HISTORIC PRESERVATION BOARD

HISTORIC PRESERVATION BOARD MEETING

PUBLIC HEARING
144 STATE STREET (Winter Street frontage)

TO: Chair Pollard and Members of the Historic Preservation Board
FROM: Deborah Andrews, Historic Preservation Program Manager
Rob Wiener, Preservation Compliance Coordinator
DATE: June 11, 2021
RE: June 16, 2021 PUBLIC HEARING – Final Review of Proposed New
Construction – Application: HPBR-001408

Window bay revisions:

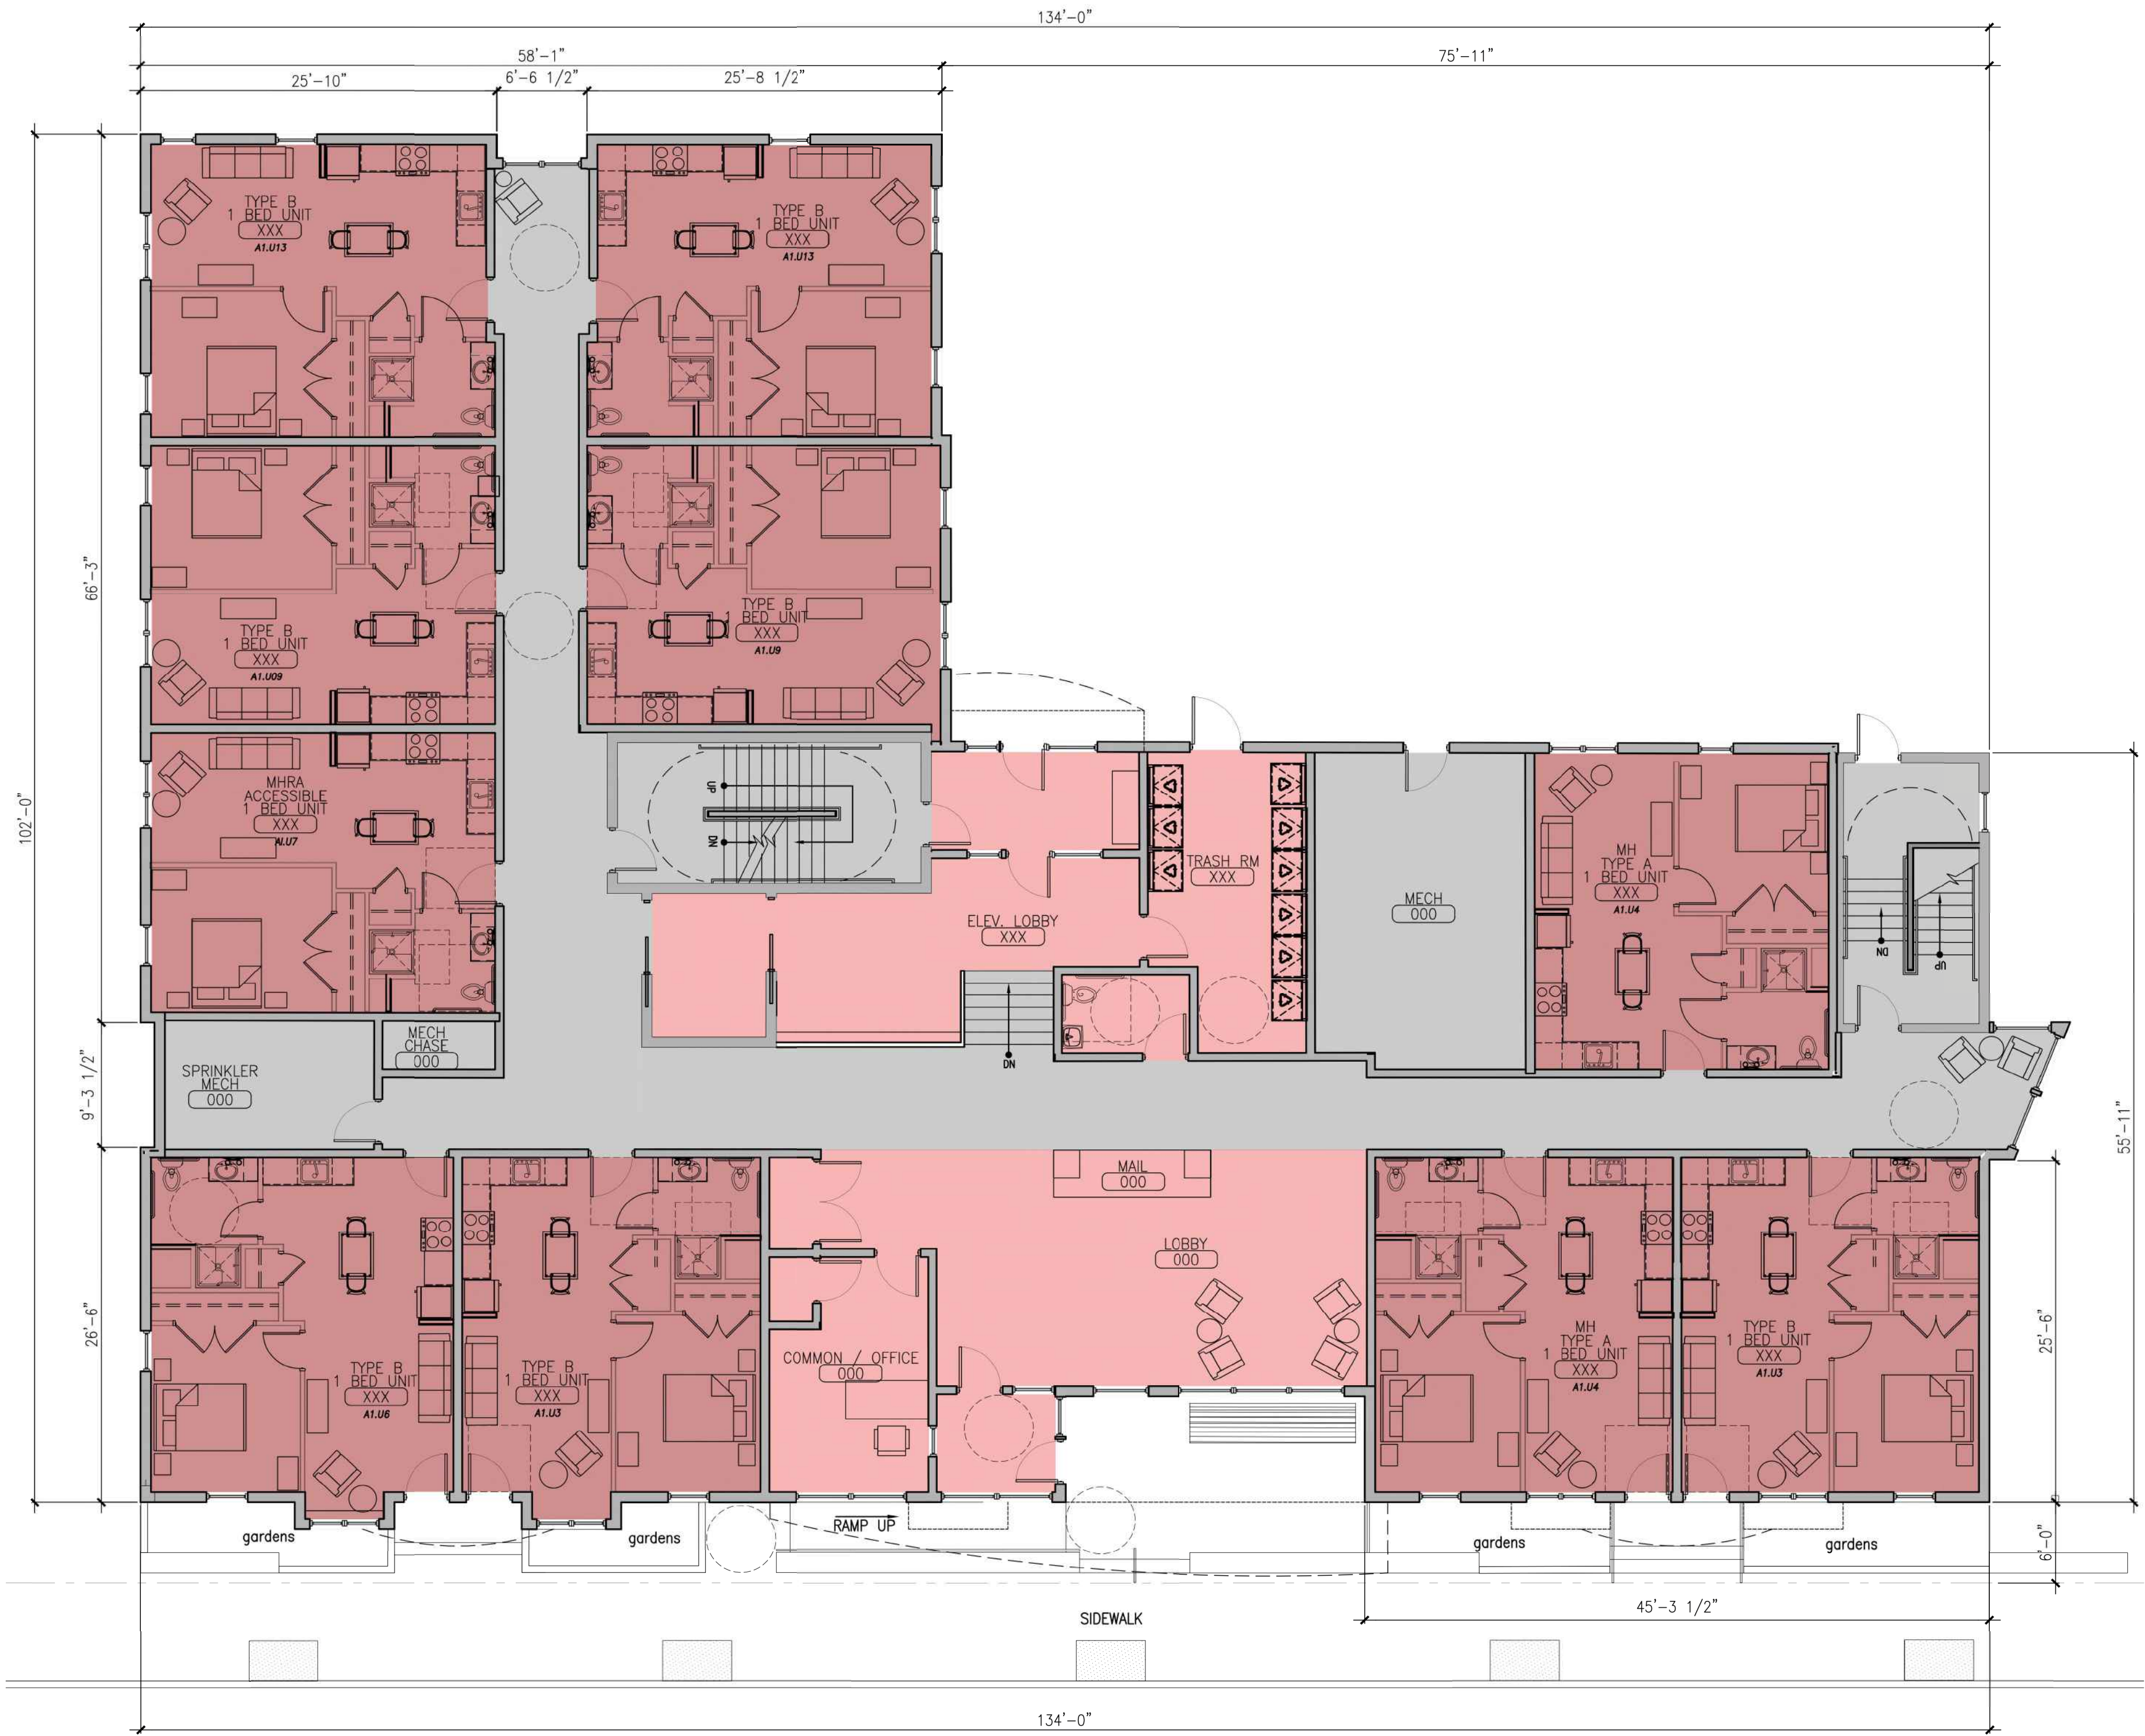
- The longer, narrower windows that appear in various locations have been mulled as pairs and surrounded by trim. Do Board members agree that this is more successful than in the earlier design?

The bays on the 4 story portion of the building stop short of the roof line.

The narrow windows between the bays have been grouped with the use of trim.

A3 RAILING ELEVATION - ENLARGED ENTRY ELEVATION
SCALE: $\frac{3}{8}" = 1'-0"$

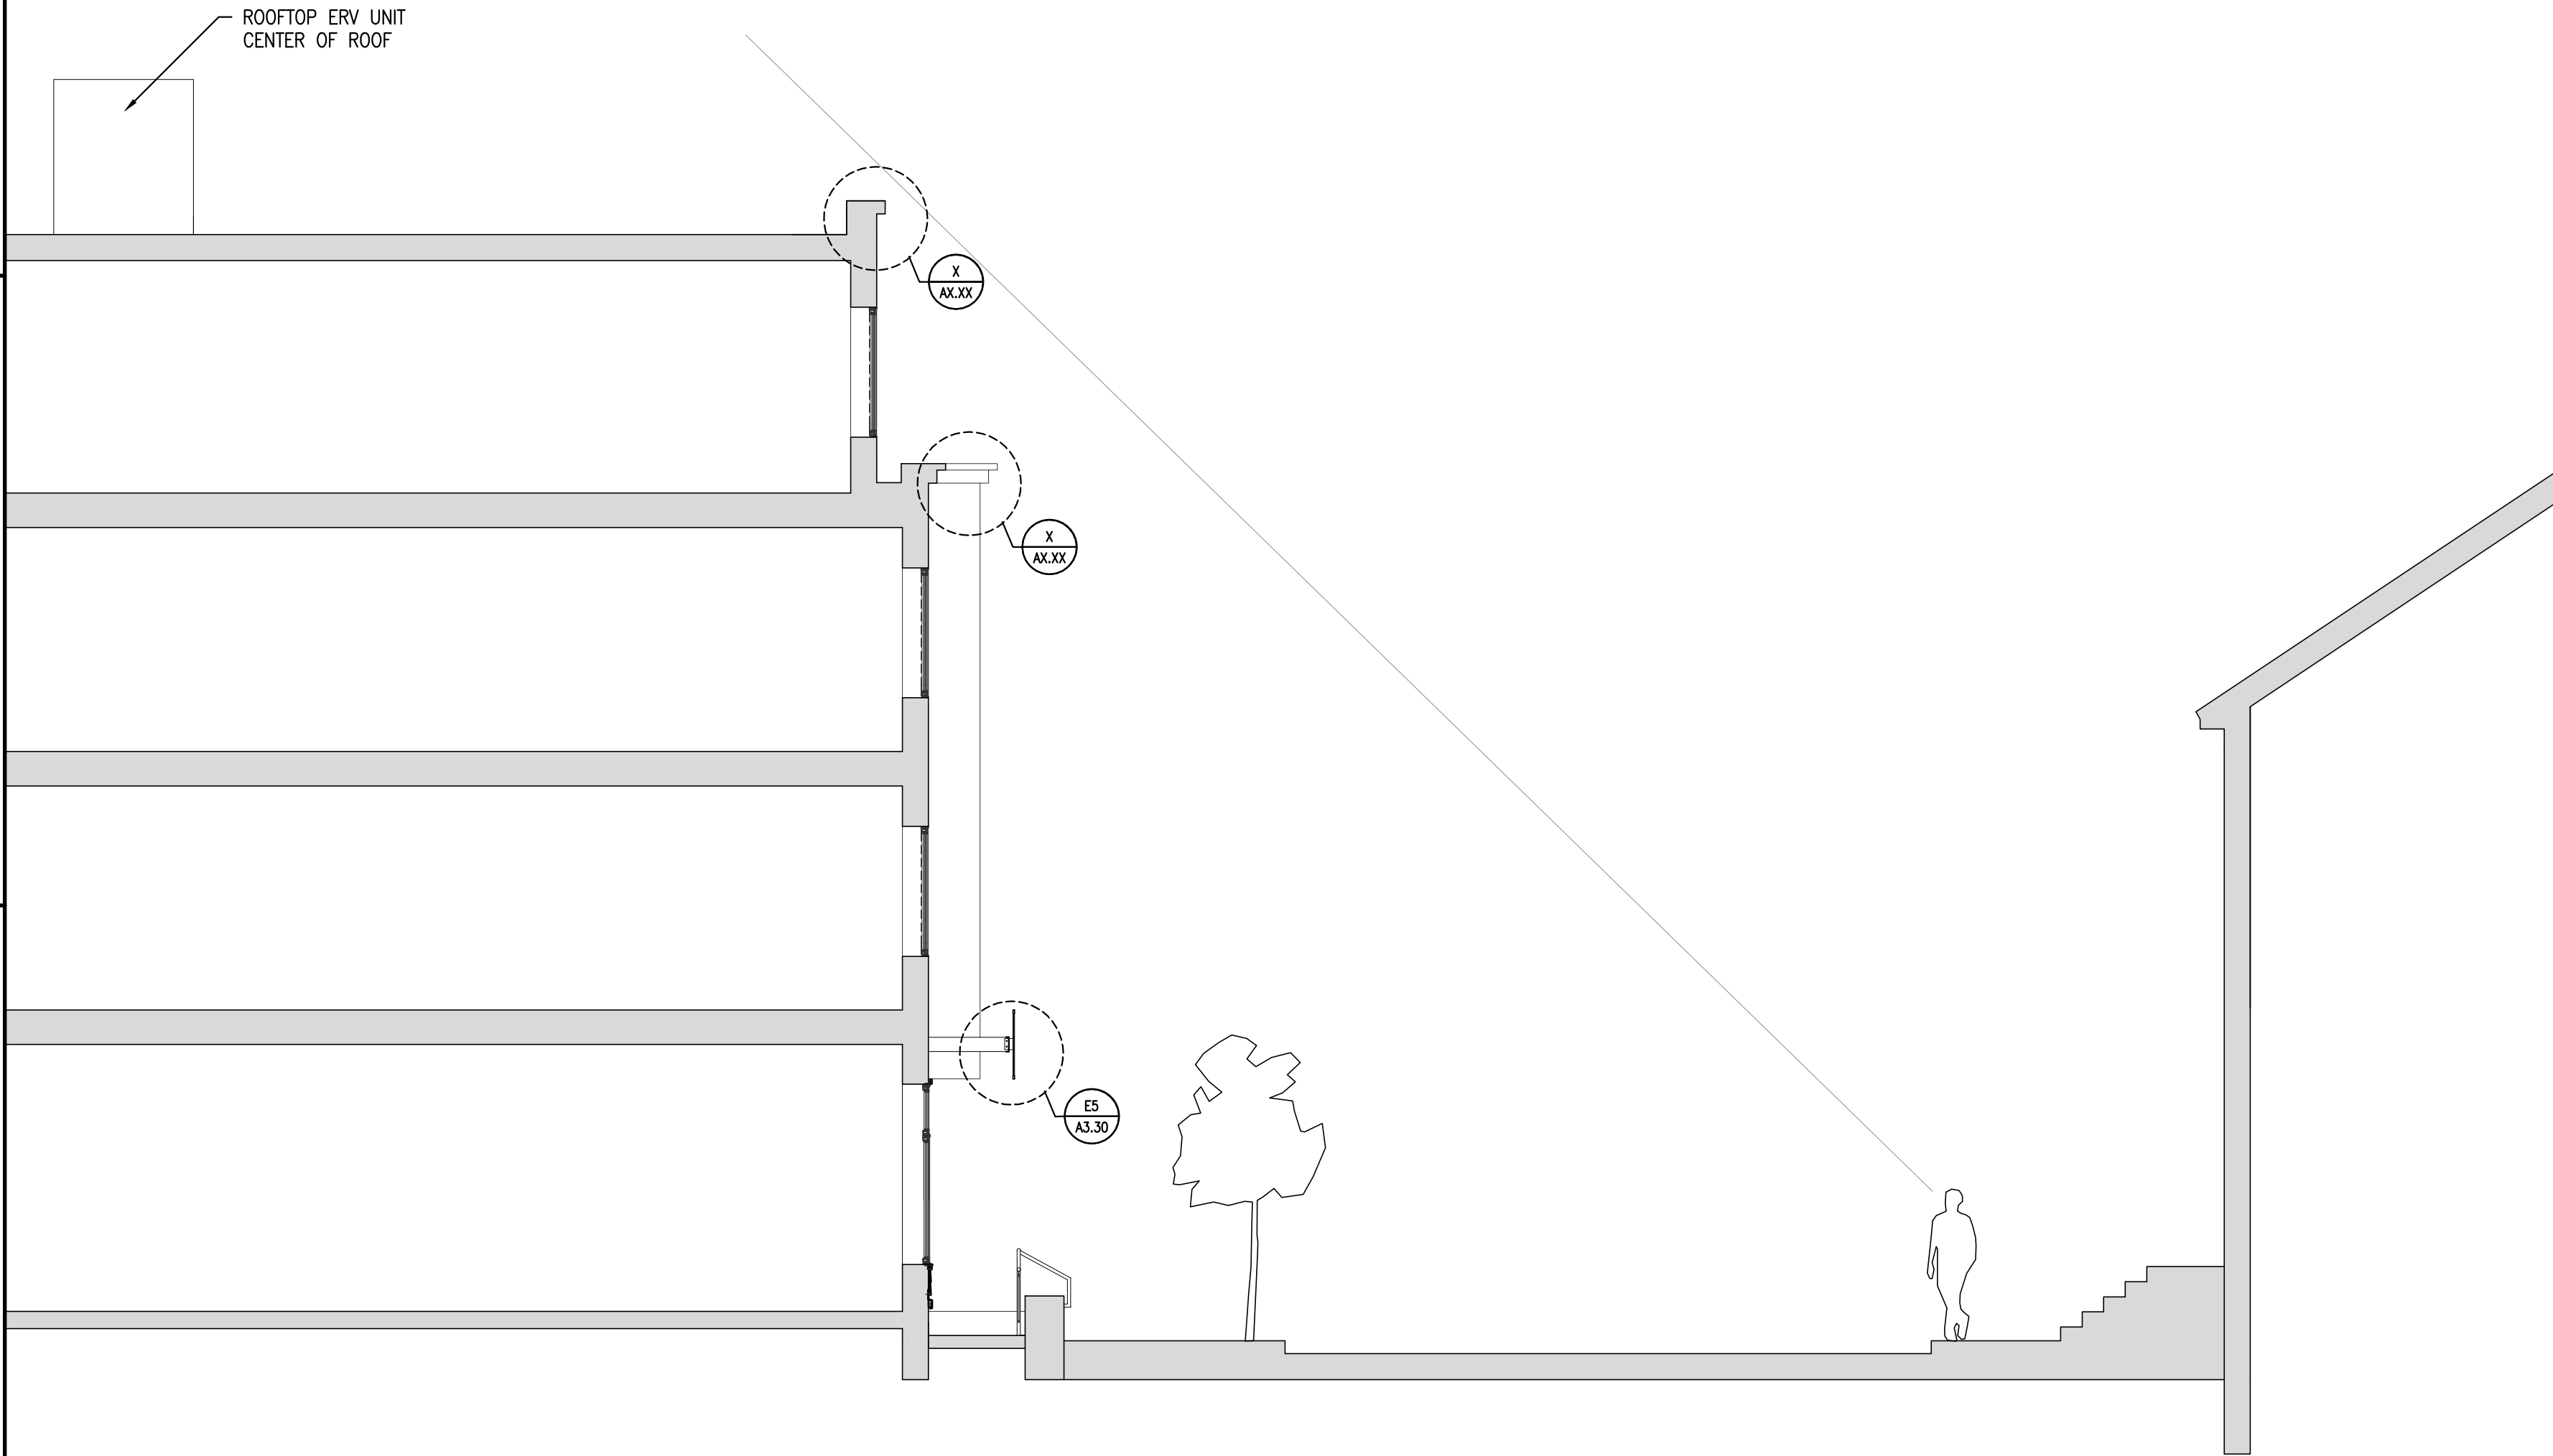
- The railing design is provided on the details page of the plans, A3.30. A steel frame is to match the frame of the perforated panels over parts of the first floor, and will be painted the same; perhaps the frame will enclose perforated panels like above, but they have been omitted from the detail for a better view. Railings themselves are simple pipe rails.
- Staff imagines that similar pipe railings will be included for the stairs facing Winter Street, though they don't appear on the latest rendering.
- The base of the building and the front stairs and planters are to be simple poured concrete.
- There are no visible exterior lighting fixtures – only recessed or otherwise concealed entry lighting.

Railing detail has been provided.

The railing is a simply 1 ½” pipe rail with a repeating rectangular frame pattern that speaks to similar detailing of the metal canopy at the entrances.

E5 ENLARGED UNIT ENTRY ELEVATION
SCALE: $\frac{1}{2}" = 1'-0"$

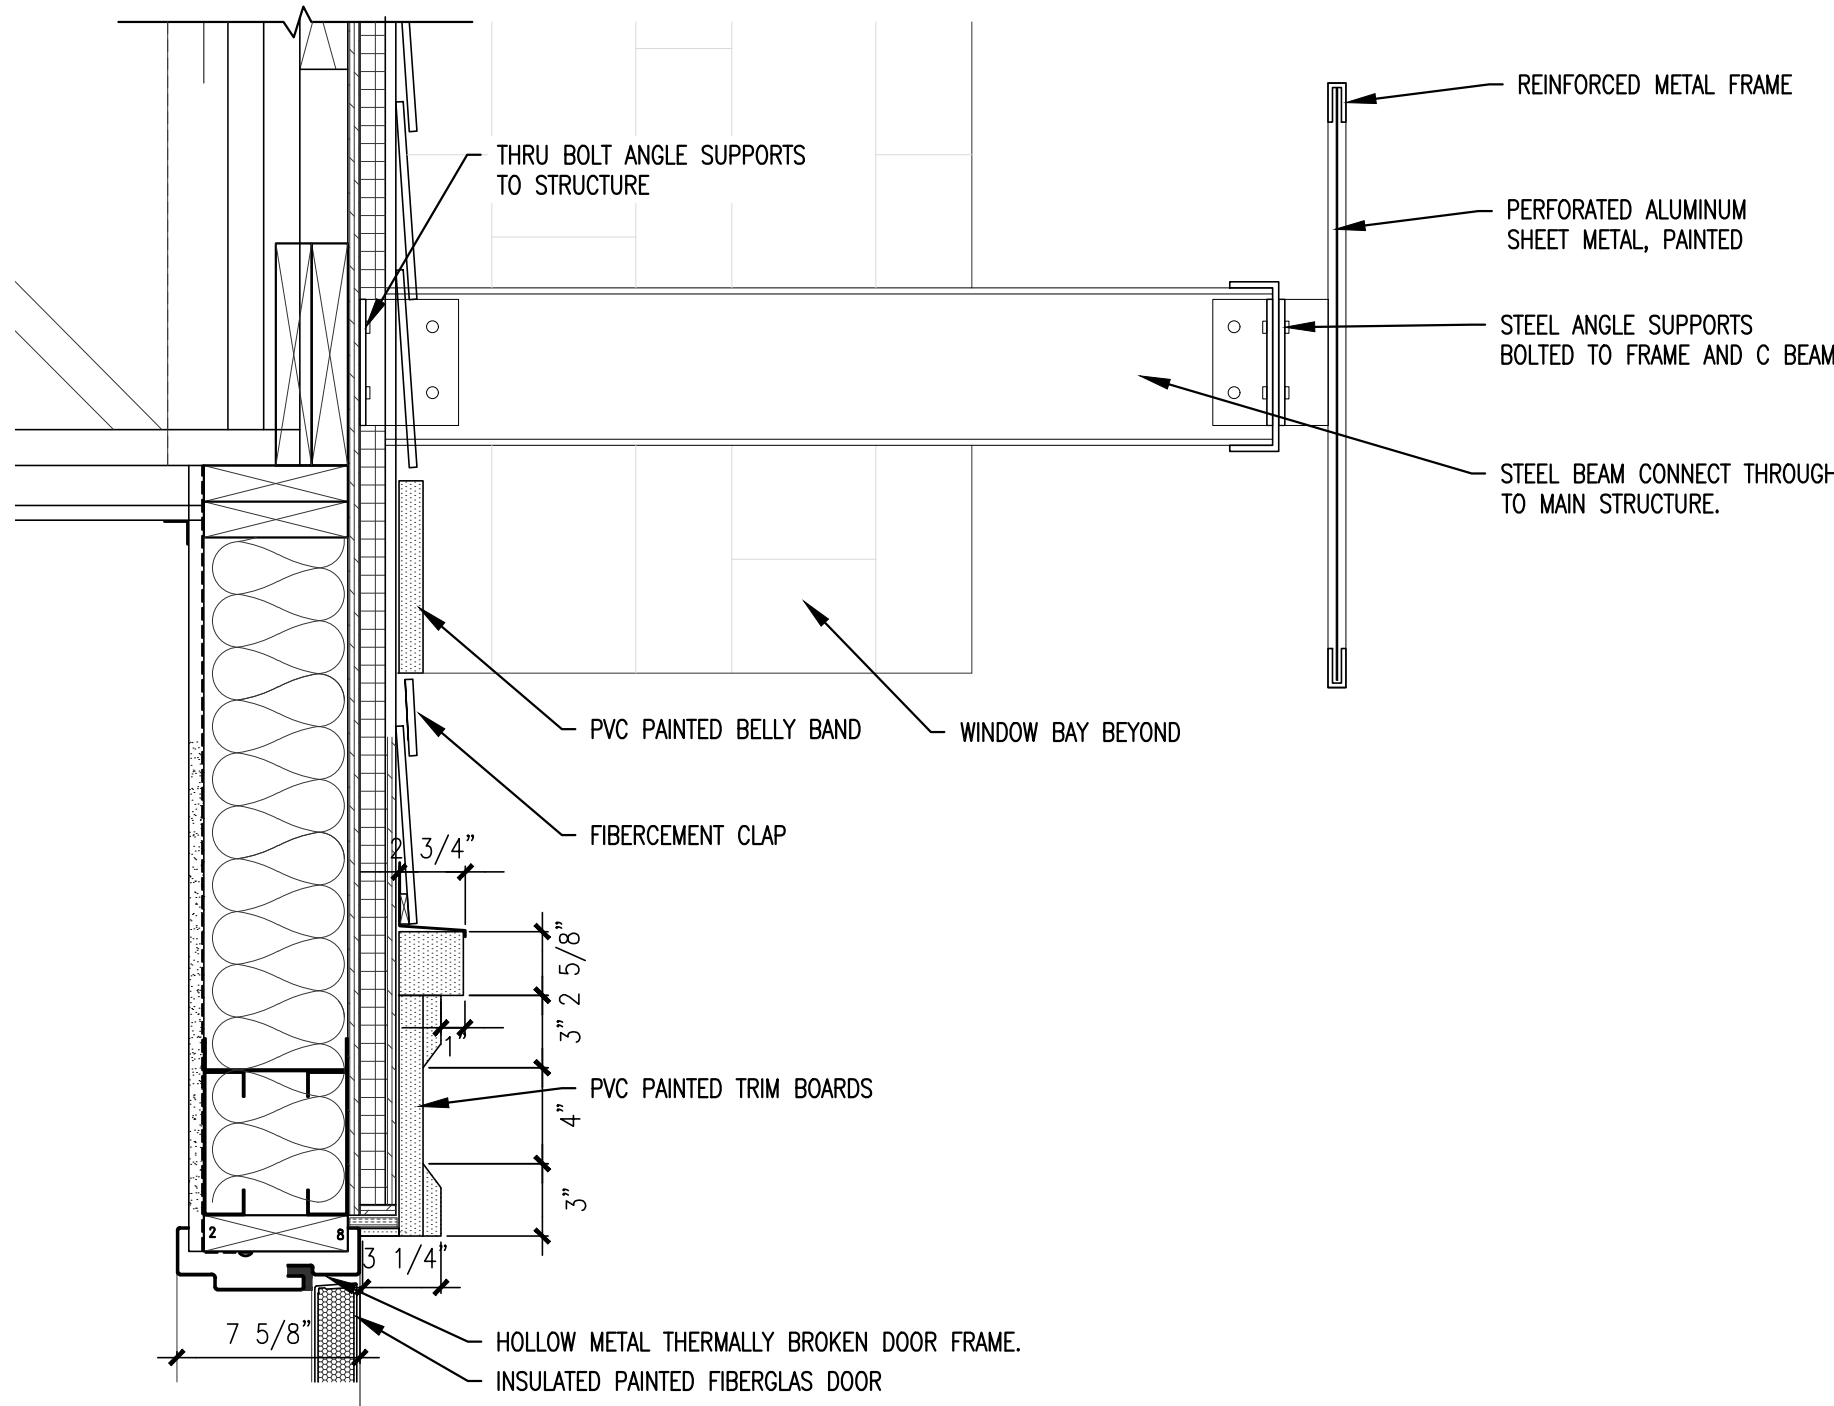
- Board members may wish to comment on the perforated metal screen, now used only to highlight entrances, with the screen over the primary Winter Street entrance shown as 7" taller than the secondary ones.

Reduced amount of metal band/canopy.

The perforated metal band is only located at the main entry, the rear entry and over each “townhouse” entrance. In order to de-emphasize the individual unit entries, the band at the townhouse locations is smaller in scale. A section detail and axon of the band has been provided.
